Symmetry Park, Knowsley, Merseyside

Response to Knowsley Council Highways Comments

VN212041

DRAWING NUMBER: VN212041-TR104

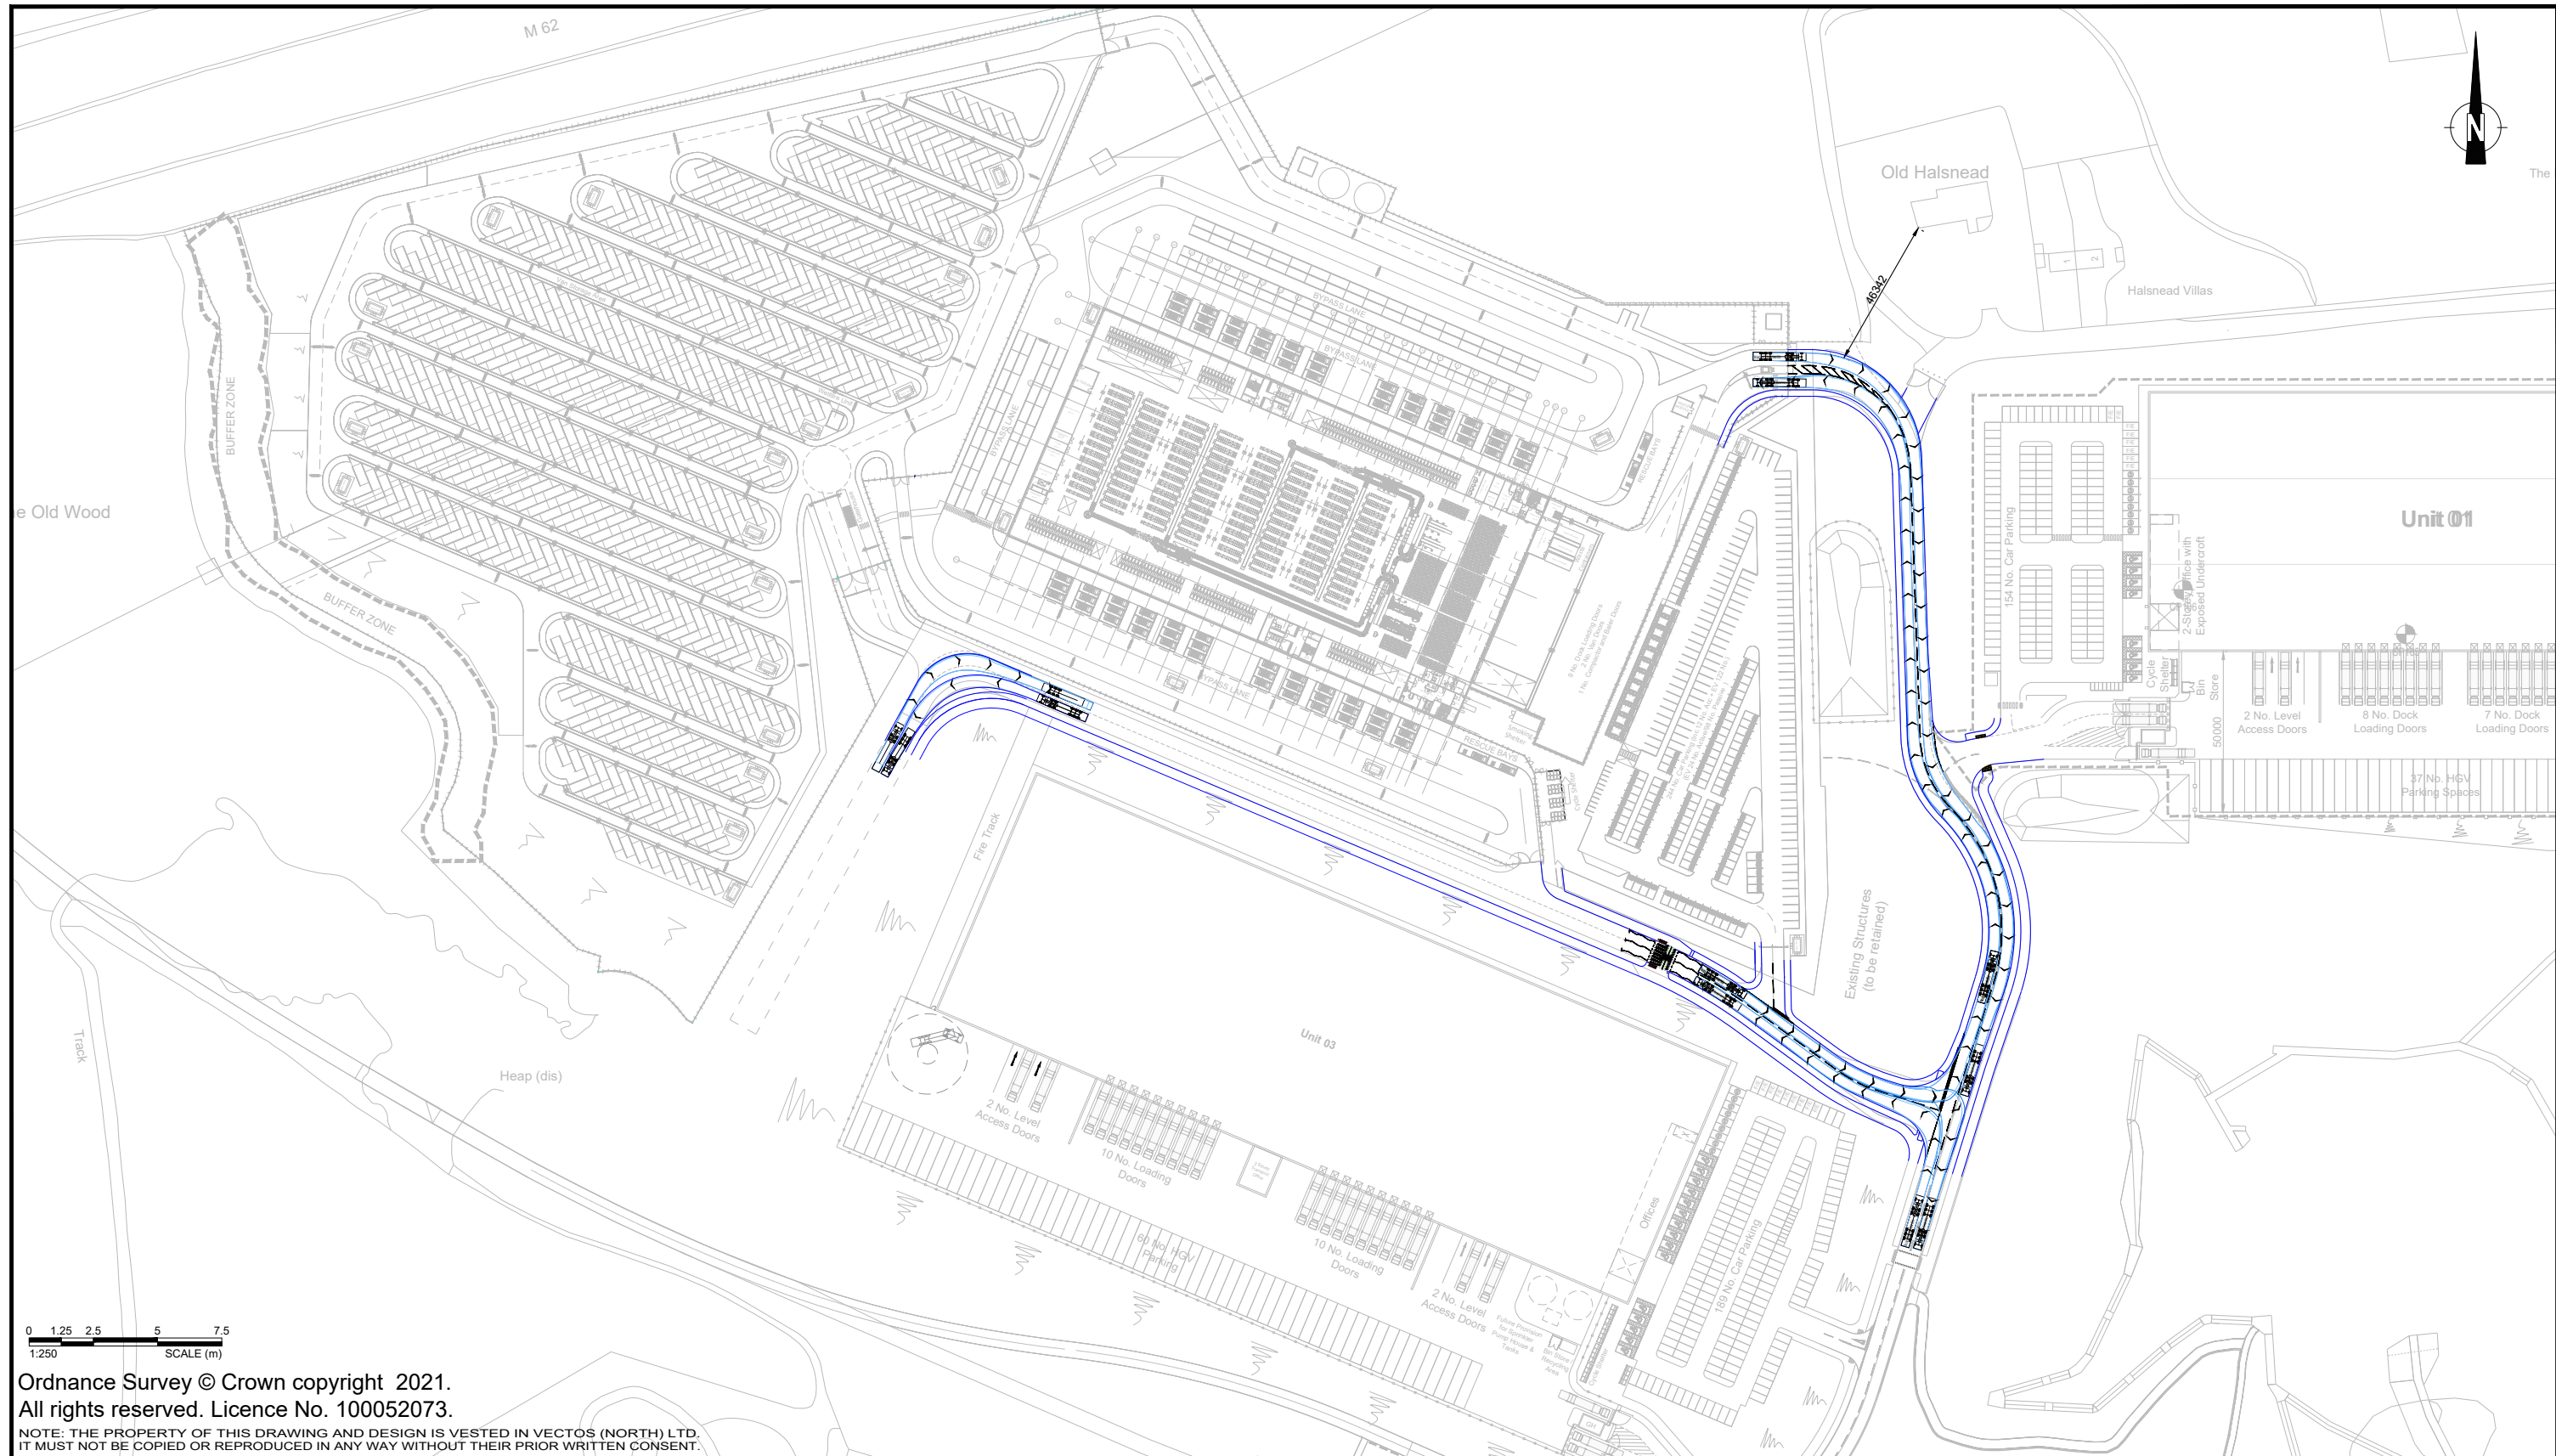
The radii of the bend will need to be increased slightly to allow for additional space as the HGVs wheels are potentially touching the kerb of the carriageway – the increase in radii should be no less than 2.0m.

11. The corner radii have been amended as suggested and this is shown in **Drawing VN212041-D100 E** and the swept path analysis is shown in **Drawing VN212041-TR104 E**.

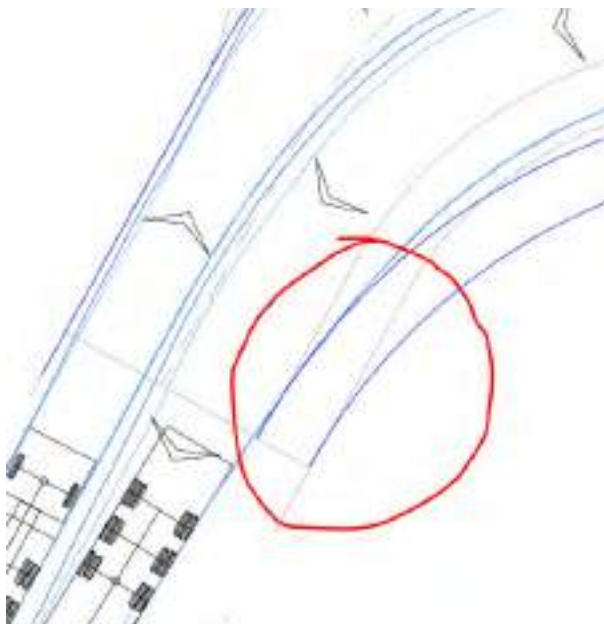
The bend at the end of the intersecting lane between Units 2 and Units 3 has been widened slightly to allow for two HGVs to pass and to future proof the route. As seen from the below print screen, although the bend has been widened, it is still very tight. The radii of the bend will need to be increased slightly to allow for additional space as the HGVs wheels are potentially touching the kerb of the carriageway – the increase in radii should be no less than 2.0m

Unit 1

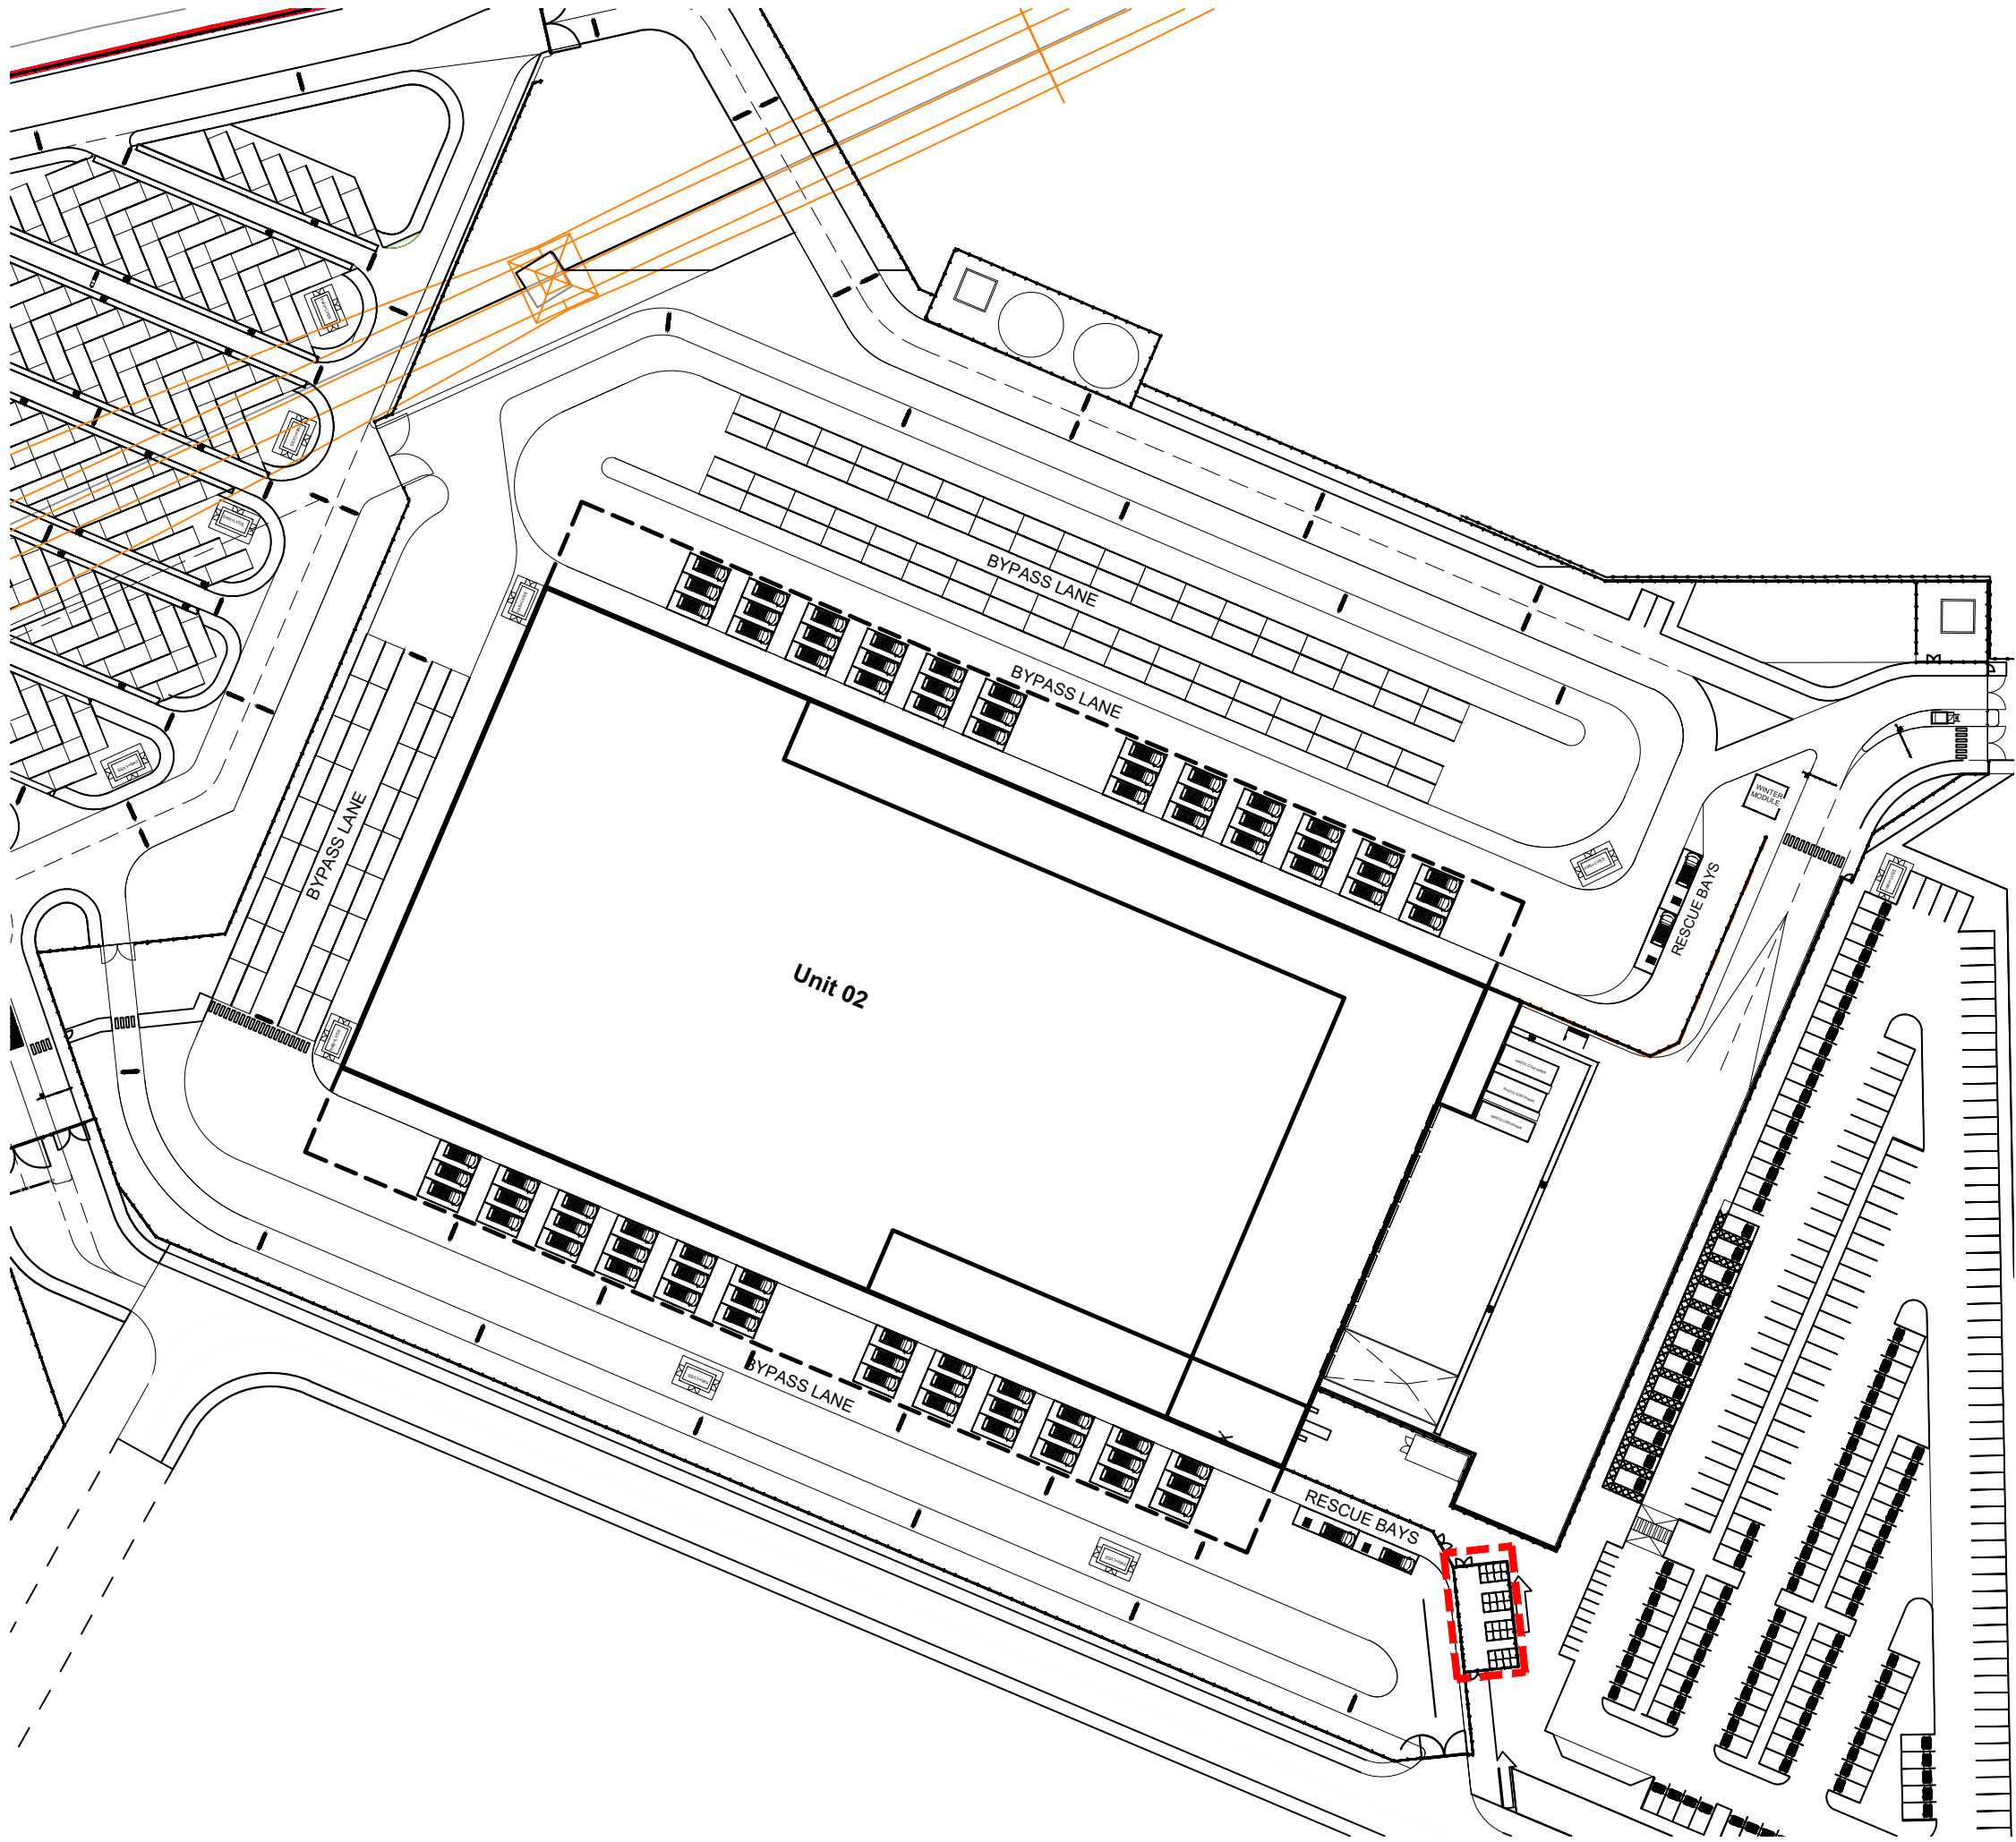
The Unit 1 access (previously approved) has been amended slightly. A Non-Material Amendment application is expected to be submitted for this shortly. The access will be reviewed then, although it should be noted that the access is not ideal in its current form. The access does not meet perpendicular with the internal carriageway and drivers will likely need to crane their necks to check for vehicles travelling south.
